City of Portland, Maine – Building or Use Permit Application 389 Congress Street, 04101, Tel: (207) 874-8703, FAX: 874-8716

Location of Construction: Waymouth St C.D.I.		Owner: Jerry & Mary Jean Crouter		Phone:		Permit No: 990222	
Owner Address: 51 Melrose St Portland		Lessee/Buyer's Name:		Phone:		BusinessName:	
Contractor Name: Stephen Berube		Address: 28 Vail St Portland ME 04103		Phone: 772-2541 / 766-0044 (site)		<div style="border: 2px solid black; padding: 5px; text-align: center;"> PERMIT ISSUED Permit Issued: MAR 17 1999 CITY OF PORTLAND </div>	
Past Use: 1-family		Proposed Use: Same		COST OF WORK: \$ 20,000 PERMIT FEE: \$ 130.00		INSPECTION: Use Group: Type:	
Proposed Project Description: Construct deck & sunporch interior renovatons		PEDESTRIAN ACTIVITIES DISTRICT (P.A.D.) Action: Approved <input type="checkbox"/> Approved with Conditions: <input type="checkbox"/> Denied <input type="checkbox"/>		Signature: _____ Date: _____		Zone: CBL: 083a-L-005 IR-2 Zoning Approval:	
Permit Taken By: SP (via mail)		Date Applied For: March 11, 1999		Special Zone or Reviews: <input type="checkbox"/> Shoreland <input type="checkbox"/> Wetland <input type="checkbox"/> Flood Zone <input t

PLOT PLAN

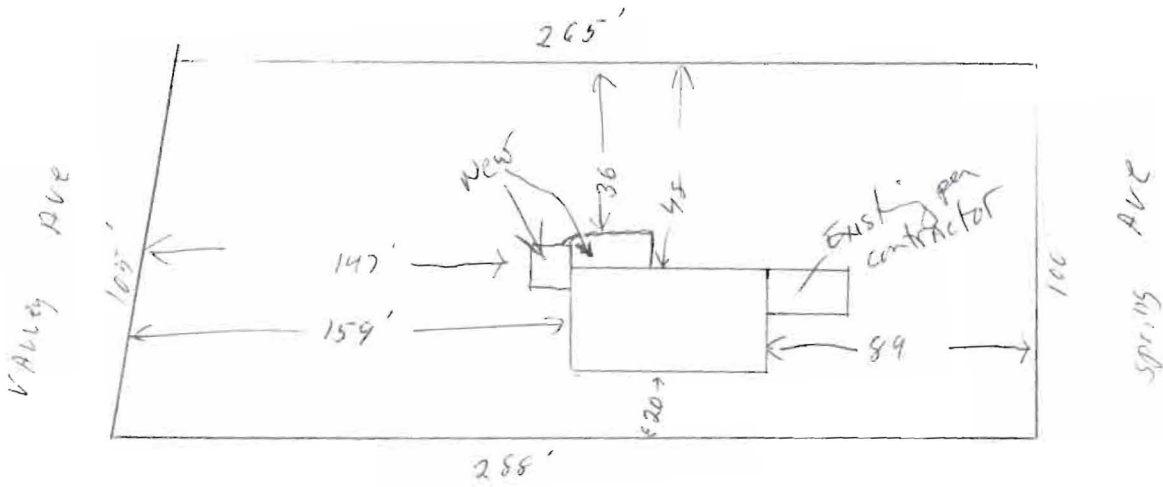
Front Yard - 25' req N/A

Rear Yard - 25' req - 36' shown

Side Yard - 20' req - 147' shown

Lot Area - 20,000^{sq} req 22,936^{sq} shown
